# City of Alachua

## Planning & Community Development Department Staff Report

January 8, 2019

<b>SUBJECT:</b>	A request for consideration of a Preliminary Plat and Final PD Plan, which proposes the subdivision of the subject property into a total of 126 lots, with associated common areas and right-of-way
<b>AGENT:</b>	Eric Warren, P.E., Poulos & Bennett, LLC
<b>APPLICANT/ PROPERTY OWNER:</b>	M3 Alachua, LLC
<b>PARCEL ID NUMBER(S):</b>	03042-050-006, 03042-050-007, 03042-052-002, 03042-052-003, 03042-052-004, 03042-052-005, and 03042-052-006
<b>FLUM DESIGNATION:</b>	Moderate Density Residential
<b>ZONING:</b>	Planned Development – Residential (PD-R)
<b>OVERLAY:</b>	N/A
<b>ACREAGE:</b>	±35.82 acres
<b>PROJECT PLANNER:</b>	Justin Tabor, AICP
<b>RECOMMENDATION:</b>	Staff recommends that the Planning & Zoning Board transmit the Alachua West PD-R Preliminary Plat and Final PD Plan to the City Commission with a recommendation to approve, subject to the three (3) conditions provided in Exhibit “A” an located on page 21 of the January 8, 2019 Staff Report to the Planning & Zoning Board.

Figure 2. Alachua West PD-R Preliminary Plat & Final PD Plan (Sheet 2.00)

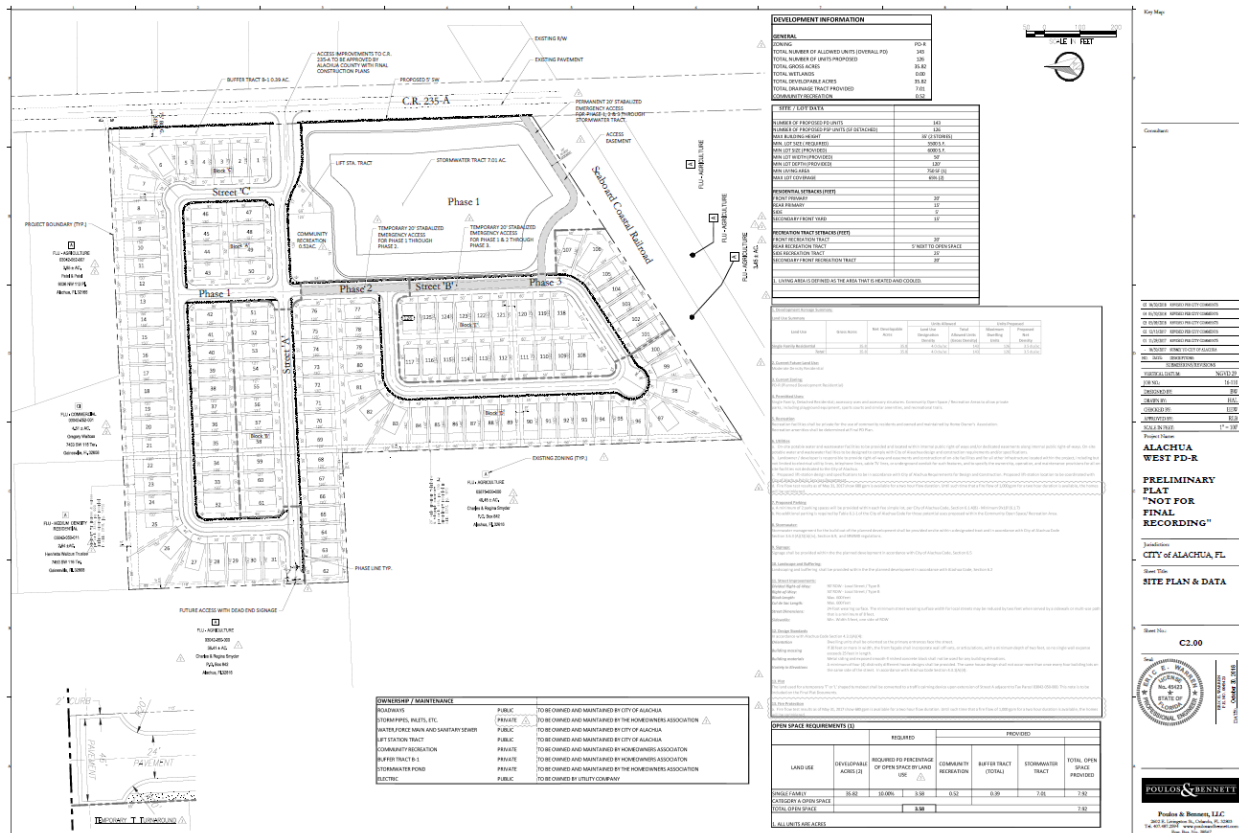
3. The applicant must address ownership and maintenance of "storm pipes, inlets, etc." Sheet C2.00 indicates City maintenance. As noted in the comments provided by the Public Services Department (in a memorandum from Rodolfo Valladares, P.E., Public Services Director) dated December 13, 2017, storm water piping and all associated items (inlets, all storm water facilities, etc.) shall be owned and maintained by the homeowner's association.

7. Sheet C2.00 notes the location of a 20' stabilized emergency access. The note states the emergency access is for Phase 1 and Phase 2, however, the emergency access connecting from CR 235-A to Street "B" in Phase 3 will be required to remain and to serve as secondary access for the development. Revise note on C2.00 accordingly.

8. A "side street" setback is not established for residential lots by Ordinance 17-10, rather, such area is referenced as the Front (secondary). Delete "side street" setback from the notes on Sheet C2.00 as it duplicates the setback for "secondary front yard".

9. The reference in the Open Space Requirements table, Sheet C2.00 to "(38-1234)" does not appear to be applicable to the project. Please delete.
10. Delete reference to "Median Tract" on Sheet C2.00.

***Response: The Ownership / Maintenance Table has been updated to reflect "Private" ownership.***
